ENGINEERING CHANGE NOTICE

1. ECN 666067

6. Project Title/No./Work Order No.	7. Bldg./Sys./Fac. No.	8. Approval Designator	
		Interim Stabilization, Essential Drawings, 113340	241-G/200-GEN	N/A

RPP-7567, REPORT ON NEW PUMPING SYSTEM SOFTWARE ON PUMPING
INSTRUMENTATION AND CONTROL SKIDS

LAD 7 - --- Total Rungs in File = 36

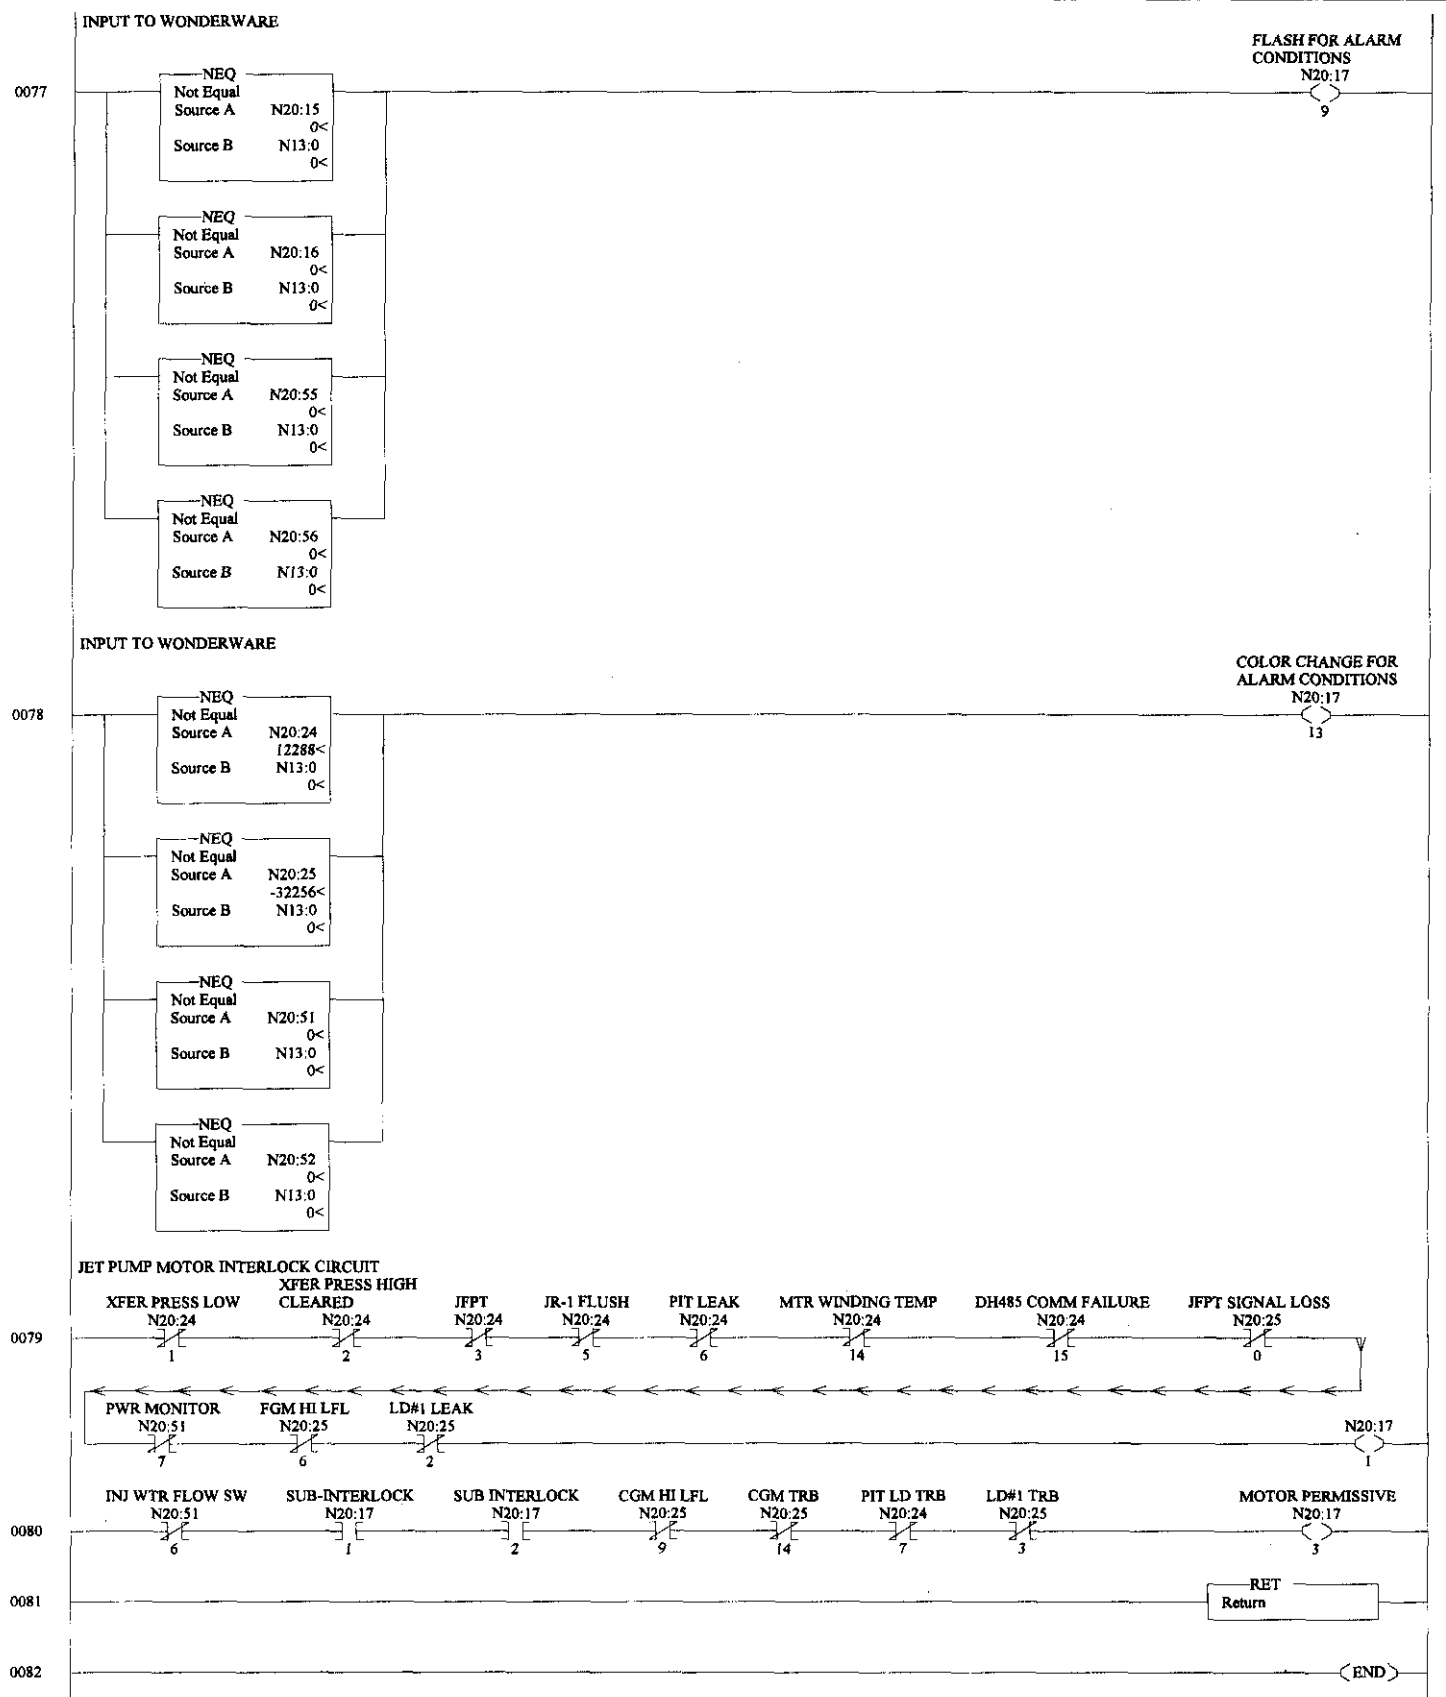
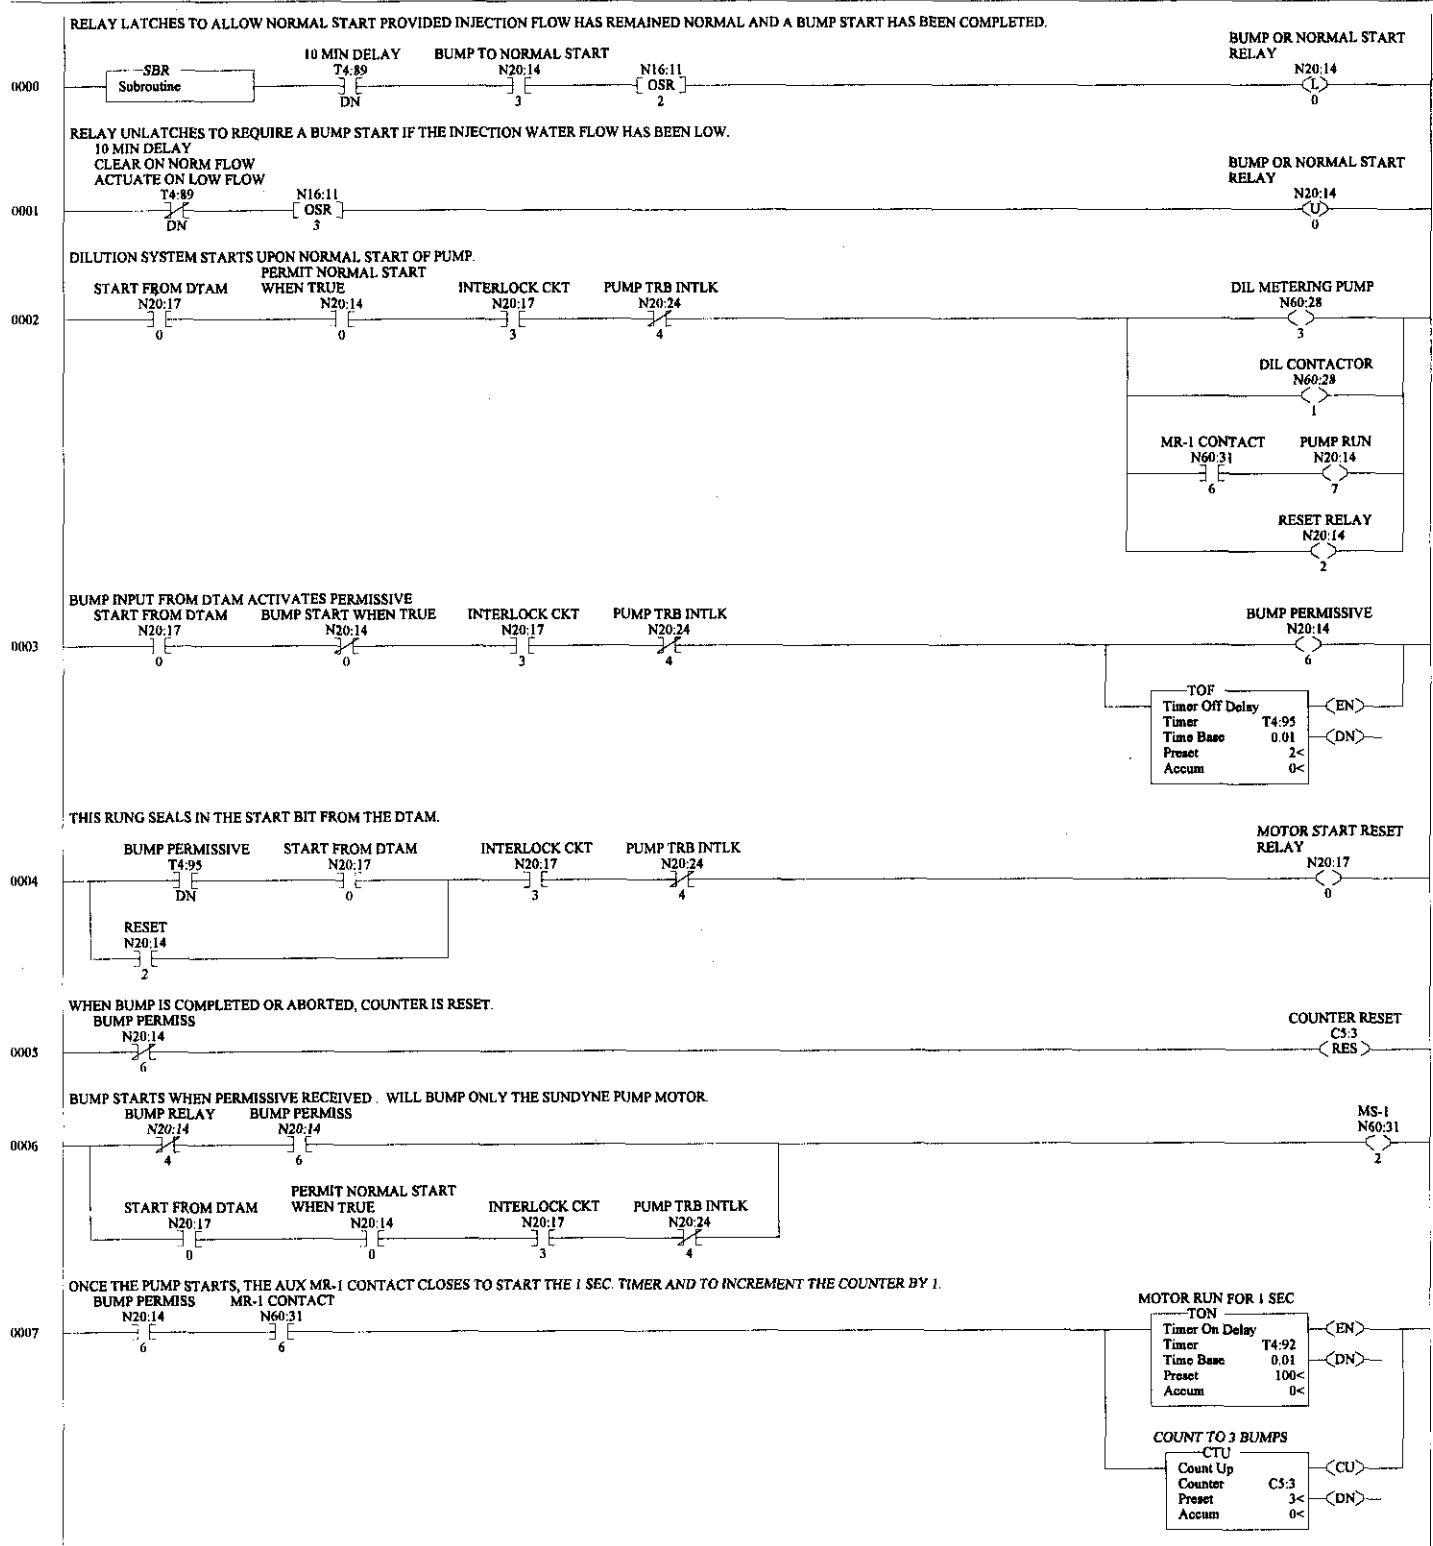
6.6 Ladder 7 has rung 0 replaced with new rungs 0 through 16. These new rungs are used to determine whether a bump or normal start will occur; provide for the normal or bump start sequence; and provide for injection pump shutdown after the saltwell pump shuts down. The following explains the ladder logic.

6.6.1 Rungs 0 and 1 are used to control the bump or normal start of the saltwell pump. Latching relays are used so after the rungs become false the contacts associated with the latched or unlatched condition will remain either true or false until the latch relay condition is changed. The 10-minute timer contacts from ladder 5 are used since it monitors the injection water flow switch. When there is no or low injection water flow, the 10-minute timer-done contact in rung 1 is **TRUE** and the "bump or normal" relay is unlatched, thus forcing a bump start when the saltwell pump is started. In order for the saltwell pump to start, the injection water must return to normal and the 10-minute timer times out. This will cause the timer-done contact in rung 1 to become **FALSE** and the timer done contact in rung 0 to become **TRUE**. However, since the bump start has not occurred, the "bump to normal start" contact is **FALSE**, thus preventing the latching relay from becoming latched. The relay in rung 0 will become latched only after the bump sequence has occurred. Once the relay is latched, the associated contacts will remain in either their true or false condition until the injection water flow switch contacts open, resetting the 10-minute timer. Resetting the 10-minute timer will then cause rung 1 to become **TRUE** and forcing a bump start the next time the saltwell pump is started.

- 6.6.3 Rung 3 is the bump permissive control. This rung becomes true when a bump start is required and the start input is received from the DTAM screen. The "bump start" contact is **TRUE** when the logic from rungs 0 and 1 are set for bump start. When the start contact from the DTAM becomes **TRUE**, the bump permissive becomes **TRUE** provided the interlock and trouble contacts are **TRUE**. The timer for Off-delay becomes **TRUE** and causes the timer contact in rung 4 to become **TRUE** to cause the motor start reset relay to become **TRUE**. The motor start reset relay is necessary for resetting the start command at the DTAM. Should the pump stop due to an interlock or pump trouble, the motor start reset relay becomes **FALSE** and makes the start from the DTAM contact **FALSE**. This prevents the pump from automatically restarting after the interlock or pump trouble clears. The Off-delay timer is used because during the transition from the bump to normal start, the bump permissive contact in rung 4 becomes **FALSE** and the seal-in contact becomes **TRUE** at approximately the same time. To ensure that the seal-in contact is true before the bump permissive becomes false, the bump permissive contact is delayed on changing to false by 0.02 seconds after the bump permissive rung 3 becomes false. The bump permissive rung when true, causes the bump permissive delay contacts in rungs 22 and 74 of ladder 5 become **FALSE** to disable the horn and shutdown output during the bump sequence. Should a fault occur such as a pump interlock break or pump trouble or should the start be aborted from the DTAM, the bump permissive rung will become **FALSE** and the contacts in rungs 22 and 74 of ladder 5 will become **TRUE** thus allowing the horn to sound and shutdown output to occur. The delay contact is used to prevent erroneous shutdown alarm and output during the switch from bump to normal start.

- 6.6.6 Rung 6 starts the pump motor either during the bump sequence or for normal run mode. There are two parallel paths in this rung, one for bump start and the other for the normal run mode. First the bump path will be explained. The bump relay contact is controlled by rung 8. This contact is **TRUE** during the 1 second run time and becomes **FALSE** during the 10-second shutdown time during the bump sequence. The bump permissive contact is **TRUE** due to rung 3 being **TRUE**. Should an interlock or pump trouble fault occur, this bump permissive contact becomes **FALSE** to stop the bump start because rung 4 becomes false causing rung 3 to become false. When both the bump relay and bump permissive are true, then the MS-1 output is **TRUE** and 120vac is sent to the motor starter to start the pump. The other parallel path starts the pump during normal start sequence. The normal start contact N20:14/0 controlled by rungs 0 and 1 must be **TRUE** for a normal start to occur. During the bump sequence, the start-from-DTAM is already **TRUE**. Upon completion of the bump sequence, the N20:14/0 contact becomes **TRUE** and the pump normal starts.

- 6.6.7 Rungs 7 through 10 are the bump sequence control. There is a bump permissive contact in each rung. This is done so the bump start can be stopped any time during the sequence. In rungs 7, 8 and 10 the bump permissive contact is **TRUE** for bump starting to proceed and becomes **FALSE** when the bump sequence is completed or stopped. In rung 9 an opposite bump permissive contact is used. This contact is **FALSE** during the bump sequence and **TRUE** when the bump sequence is completed or stopped. This contact when true causes the bump relay to unlatch and be ready for the next bump start when called upon. The bump sequence functions as follows. When the pump motor is started in rung 6, the MR-1 contact becomes **TRUE** in rung 7 causing the 1 second timer to start and the counter to increase by 1. The MR-1 contact is used to ensure that the pump motor is actually started prior to starting the 1-second timer and counter. Upon the 1-second timer timing out, the timer-done contact in rung 8 becomes **TRUE** and starts the 10-second timer. The bump relay in rung 8 also becomes **TRUE** which makes the bump relay contact in rung 6 **FALSE** and stops the pump motor. The timer-done contact in series with the bump latch relay is **TRUE** because the timer has not timed out. The bump relay contact in parallel with the 1-second timer contact in rung 8 becomes **TRUE** and seals in the 10-second timer. This is required because when the pump motor stops, the MR-1 contact in rung 7 becomes **FALSE** causing the 1 second timer to reset which then causes the timer done contact in rung 8 to go **FALSE**. The bump relay makes the associated contact in rung 6 of ladder 5 becomes **FALSE** to bypass the pump trouble during the 10 second down time during bump sequence. Upon timing out of the 10-second timer, the timer done contacts in rungs 9 and 10 become **TRUE**. Either rung 9 or 10 will become true depending upon whether the counter is at 3 or less than 3. If the counter in rung 7 is at 1 or 2, then rung 9 is **TRUE** because the counter-done contact is **TRUE** and the bump relay is unlatched causing the contact in rung 6 to become **TRUE** to start the pump again. The unlatching is allowed because the timer done contact in rung 8 is **FALSE** due to the 10-second timer timing out. The bump relay contact in rung 6 of ladder 5 become **TRUE** again to reactivate the pump trouble. When the bump relay becomes unlatched, its associated contact in rung 8 becomes **FALSE** and the 10-second timer is reset. When the counter in rung 7 is at 3, the counter done contact in rung 9 becomes **FALSE** and the counter done contact in rung 10 becomes **TRUE**. Timing out of the 10 second timer then causes rung 10 to become **TRUE** and the

- 6.6.8 Rungs 11 and 16 are for the injection pump control. Rung 11 monitors the run status of the injection pump. The N60:20/6 contact is **TRUE** when the pump is running, thus starting the 10-minute timer. This 10-minute timer corresponds to the 10-minute timer in ladder 5 for the flow switch and is used to control the injection control relay in rung 12. Rung 12 is the injection shutdown control. The injection pump will **always** be started prior to the saltwell pump starting. Therefore, the N20:14/7 contact will be **FALSE**, resetting the 30-minute timer and causing the timer-done contact T4:94/DN to be **TRUE**. The high transfer pressure contact, N20:14/9 must be **TRUE** to allow the injection pump to start by output N60:20/1 being **TRUE**. Once the injection pump starts, the 10-minute timer in rung 11 starts. Upon timing out, the associated 10-minute timer contact in rung 12 becomes **TRUE** making the injection control relay **TRUE**. The corresponding injection control contact in rung 12 becomes **TRUE** and will start the 30-minute timer. The 30-minute timer will start because the saltwell pump is not ON making the normal run contact N20:14/7 **TRUE**. If the saltwell pump is not started before the 30-minute timer times out, the injection pump will shut down. This injection pump shutdown occurs because the associated 30-minute timer contact in rung 12 becomes **FALSE** making the injection pump output **FALSE** which stops the injection pump. At the same time, the injection control relay becomes **FALSE**, which in turn causes the associated contact in rung 12 to become **FALSE** causing the 30-minute timer to reset. Resetting of the 30-minute timer causes the associated timer contact in rung 12 to become **TRUE** again, allowing the injection output to become **TRUE**. This allows for restarting of the injection pump. When the saltwell pump starts before the 30-minute timer times out, the pump normal run contact

LAD 9 - --- Total Rungs in File = 10

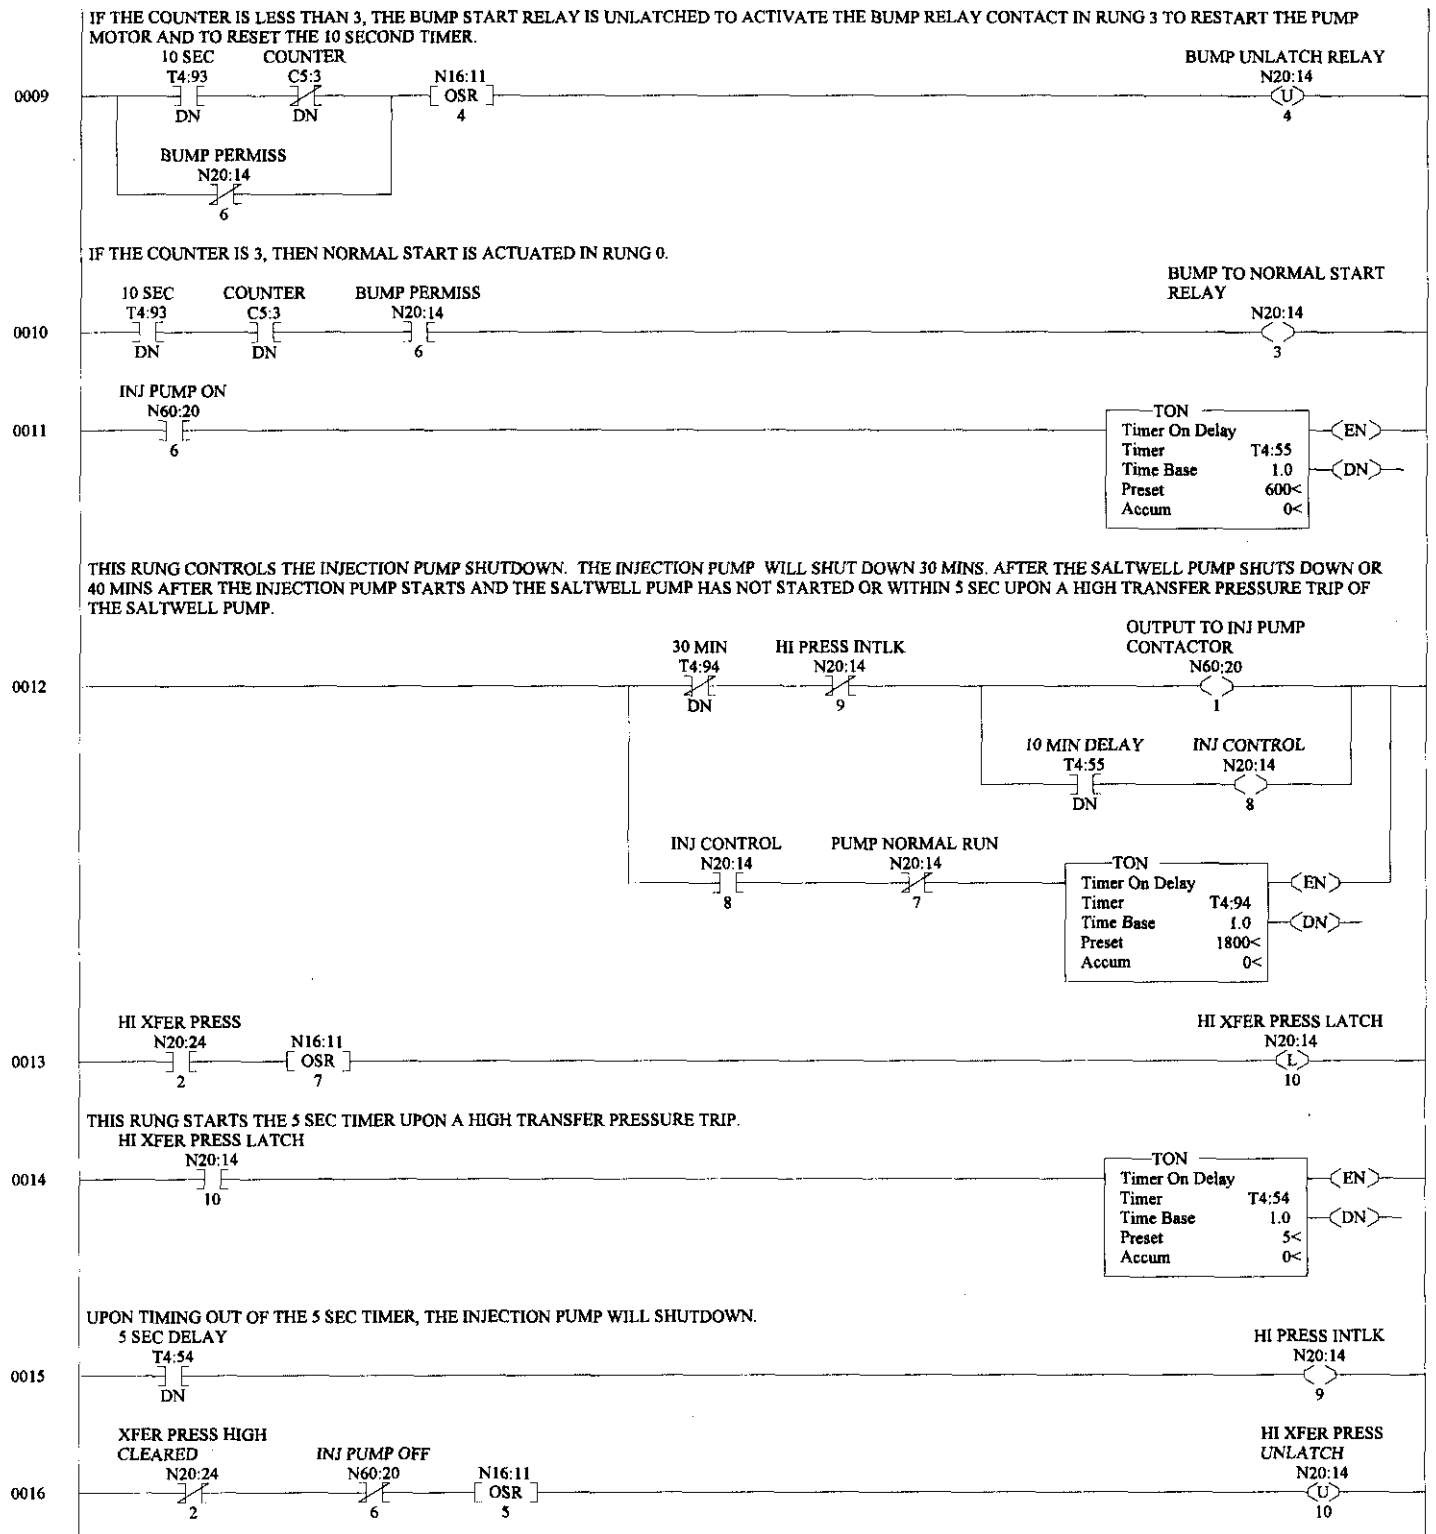
- 6.7 Ladder 9 has new rungs 4 through 7 added. These rungs are similar to rungs 0 through 3 for the jumper heat trace control. Rungs 4 through 7 control the pump piping assembly heat trace. A screen on the DTAM is provided to enter the temperature setpoint that is stored in file N31:17. The temperature is read into address N60:34.
- 6.8 Ladders 17 and 18 have tags changed to reflect the changing of the alarms. No logic changes have been made.
- 6.9 Ladder 19. An output rung is added for module 6. Outputs of address N60:20 are sent to the data 6 module outputs.
- 6.10 Ladder 20 is totally revised to use floating-point data entry and to account for the injection water being added into the pumping system.
